# Wisconsin Department of Transportation

**Proposal #09: 2673-00-70, WISC 2016 092**  
**South Nicholson Road**  
**Bridge over Oak Creek**  
**(B-40-920)**  
**Local Street**  
**Milwaukee County**

**2987-00-70, WISC 2016 095**  
**West Marquette Avenue**  
**Bridge over North Branch Oak Creek**  
**(B-40-919)**  
**Local Street**  
**Milwaukee County**

This is Addendum No. 01, which provides for the following:

Addendum No. 01  
ID 2987-00-70  
Revised Sheet 14  
April 1, 2016

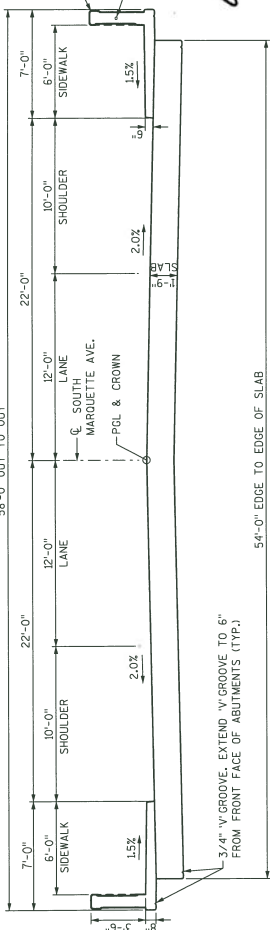
Revised Plan Sheets	
Plan Sheet	Plan Sheet Title (brief description of changes to sheet)
	ID 2673-00-70
12	Miscellaneous Quantities – Pay Item Revised as shown above
	ID 2987-00-70
14	Miscellaneous Quantities – Pay Item Revised as shown above
47	Misc. Details and General Notes – Added Pay Item to Quantities Table

Added Bid Item Quantities					
Bid Item	Item Description	Unit	Old Quantity	Revised Quantity	Proposal Total
643.0420	Traffic Control Barricades Type III	Day	0	7,200	7,200
550.0010	Pre-Boring Unconsolidated Materials	LF	0	48	48

Deleted Bid Item Quantities					
Bid Item	Item Description	Unit	Old Quantity	Revised Quantity	Proposal Total
643.0410	Traffic Control Barricades Type II	Day	7,200	-7,200	0

Addendum No. 01  
ID 2987-00-70  
Revised Sheet 47  
April 1, 2016

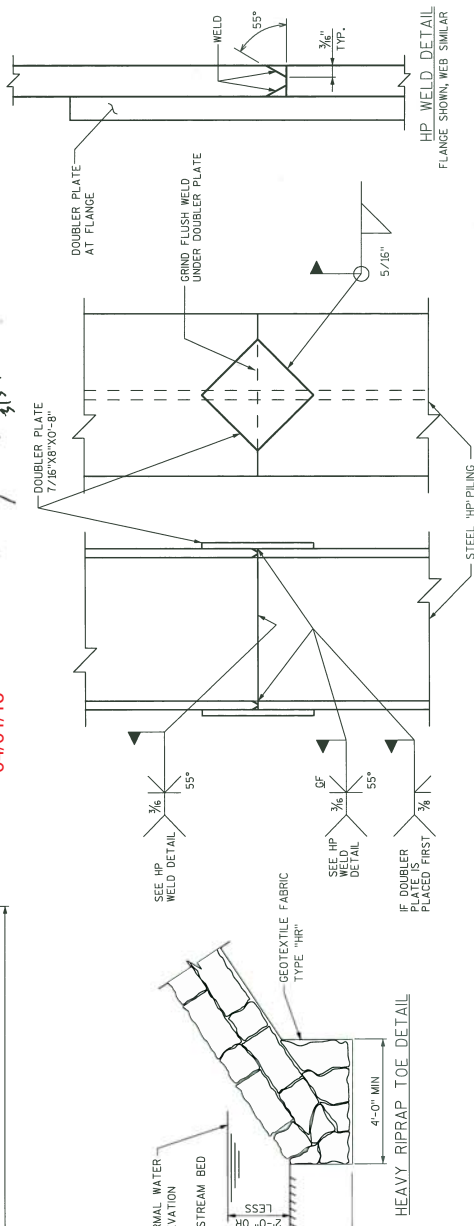
NO.	DATE	REVISION	BY
3/23/2016		ADD PREBORING PAY ITEM	WJZ

516.0500	RUBBERIZED MEMBRANE WATERPROOFING	SY	13	13		26
517.0500.5	ARCHITECTURAL SURFACE TREATMENT (B-40-919)	SY	42	42		84
550.0000	PRE-BORING UNCONSOLIDATED MATERIALS	LF	24	24		48
